CONTRACT 1725

**CIPP REHABILITATION OF THE
LOWER SAW MILL RUN INTERCEPTOR**

ADDENDUM NO. 2

GRATING PLAN H
SCALE: 3/8" = 1'-0"

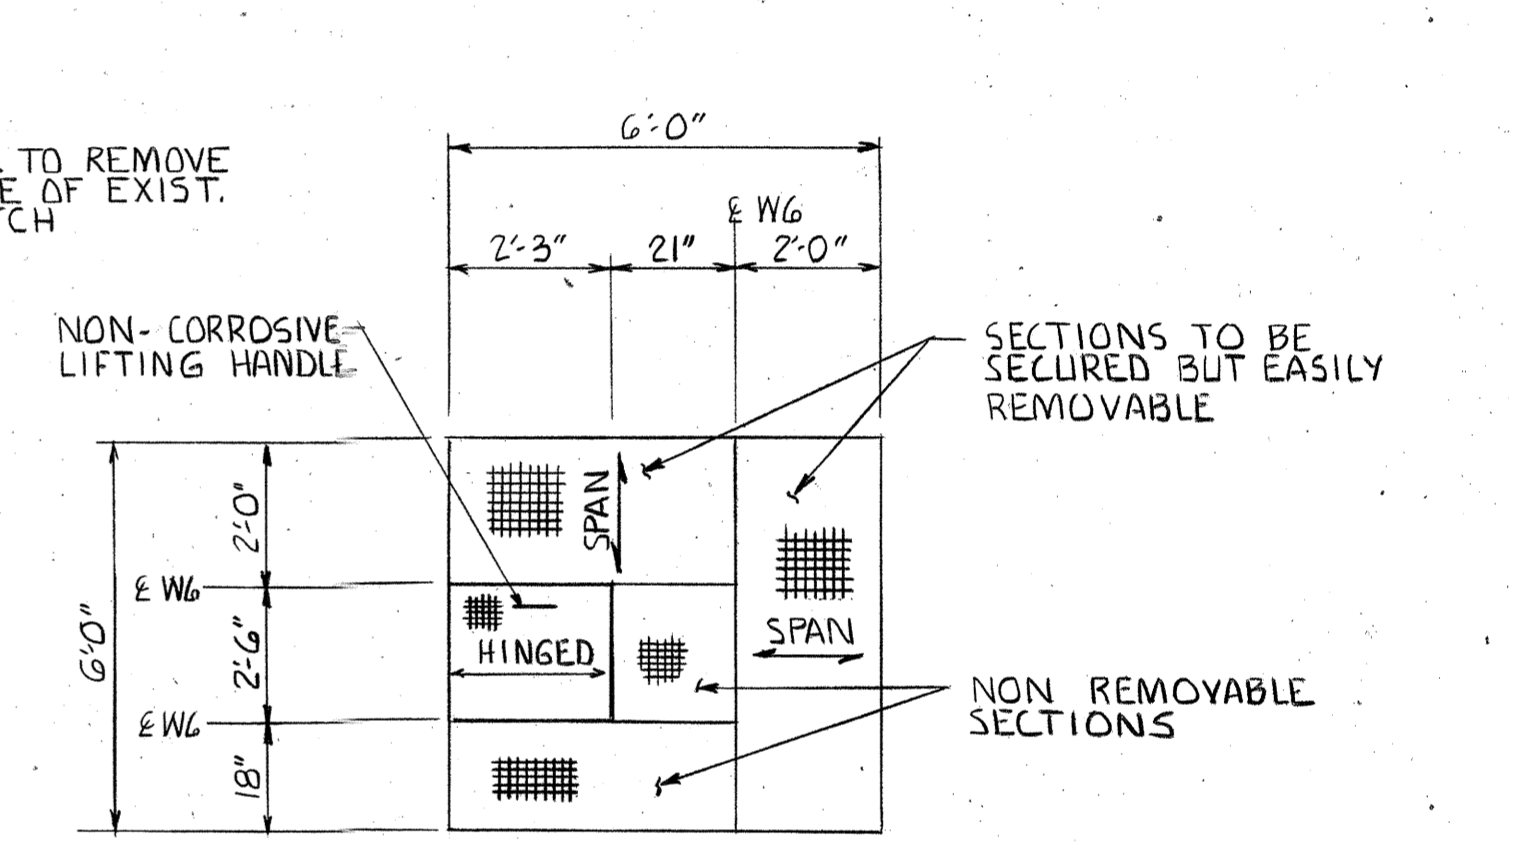
- 11.) Question: Sheet 23, Note 3 – can drawings, profiles showing size and weight of the grating, sluice gate and concrete roof be provided.

- 38.) Question: Spec. discusses potential rehabilitation to MH S-02A-00. Will the Owner provide a section detail of this manhole? Will the Owner add a bid item for this specific work?

Answer: ALCOSAN does not possess information regarding the weight of these items. Contract 940 Sheet 17 is included as an attachment with this Addendum for information only.

Answer: Rehabilitation work includes CIPP lining of incoming and outgoing interceptor pipes, paid for under Bid Item 4, and epoxy coating the interior of the concrete chamber, paid for under Bid Item 7. See attached Contract 940 Sheet 17 for additional information.

SCALE: 1"=40' SHEET 15 OF 38

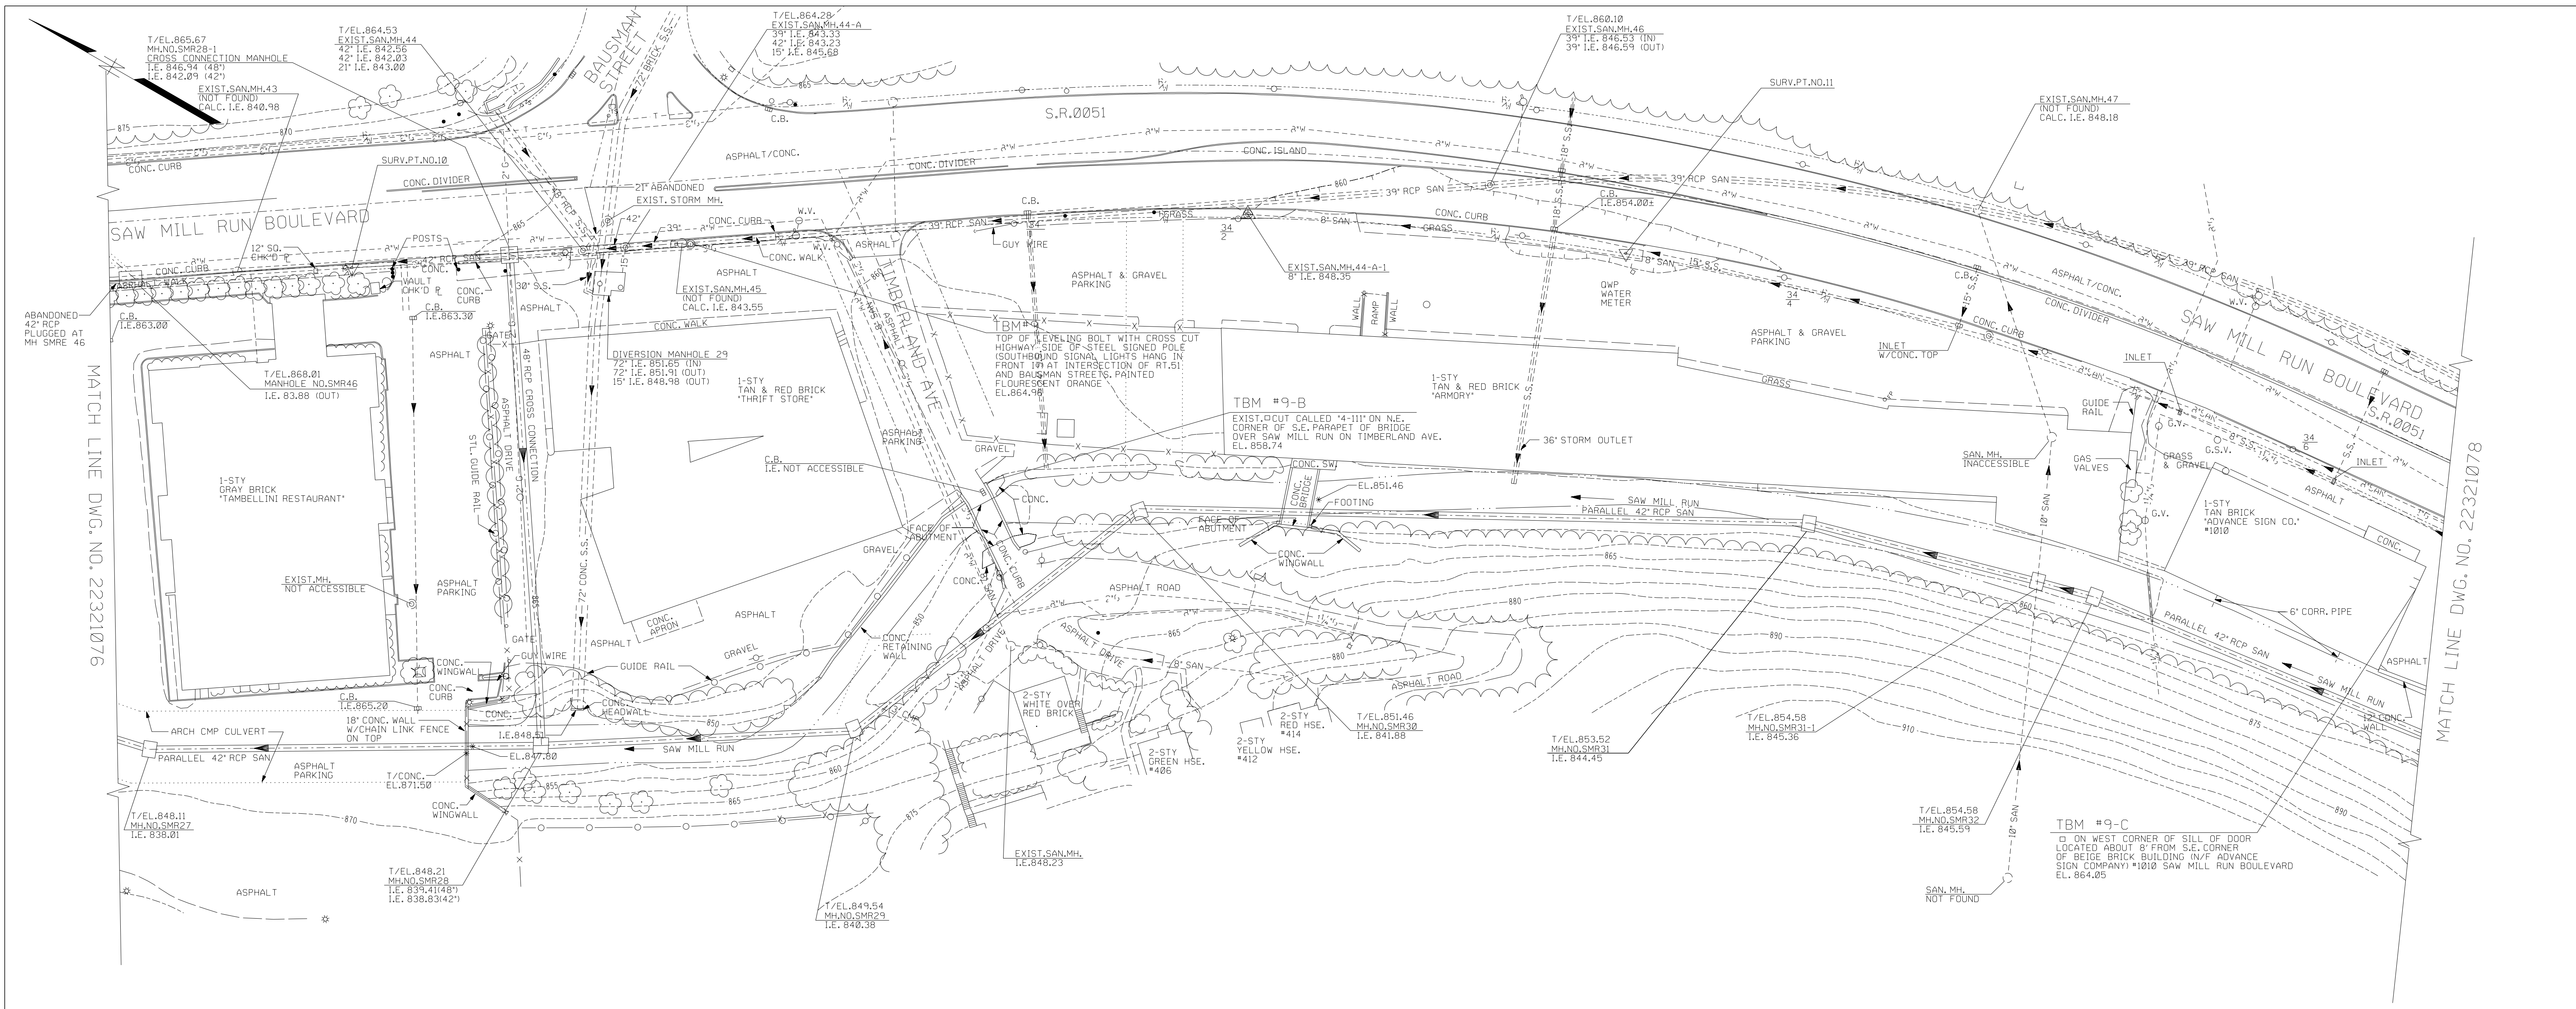
- 55.) Question: SMR 28 is in the creek and bolted down. Will the Owner provide a detailed section view of this manhole? Will the Owner provide the invert elevation of the 42” and the invert elevation of the 48” RCP?

Answer: See the Saw Mill Run Interceptor Ohio River to Conner Road Sheet 15 of 38 attached to this addendum. Coordinate with ALCOSAN for opening the manhole.
